HYUNDAI Technical Service Bulletin	GROUP CAMPAIGN	NUMBER 22-01-068H
	DATE AUGUST, 2022	MODEL(S) PALISADE (LX2)
SUBJECT: DDM (DRIVER DOOR MODULE) SOFTWARE UPDATE (SERVICE CAMPAIGN T8S)

Description: Some 2022 Palisade (LX2) vehicles may experience an intermittent inoperative adjustment function of the driver and passenger outside mirrors. The driver intermittently cannot adjust the outside mirrors.

This bulletin provides the service procedure to update the DDM (Driver Door Module) or DAU (Driver Door Area Unit) software to resolve the condition stated above.

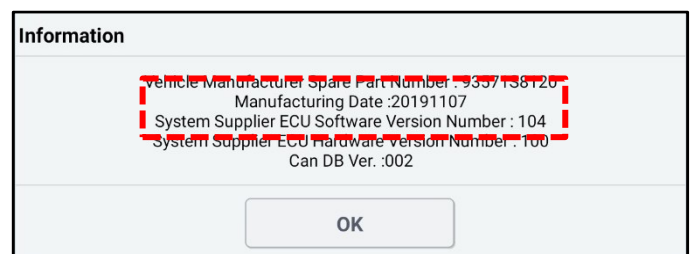
1. In the S/W Management screen, select “Driver Door Module” and then “System Identification”.

2. Compare the ROM ID to the table from above to determine if the software update is required.

In the example to the right the ROM ID version is 104/20191107.

If the DDM software does not require an update, then procedure is complete. Submit op code 20D084R2.

If the DDM software requires an update, then proceed with updating the software.
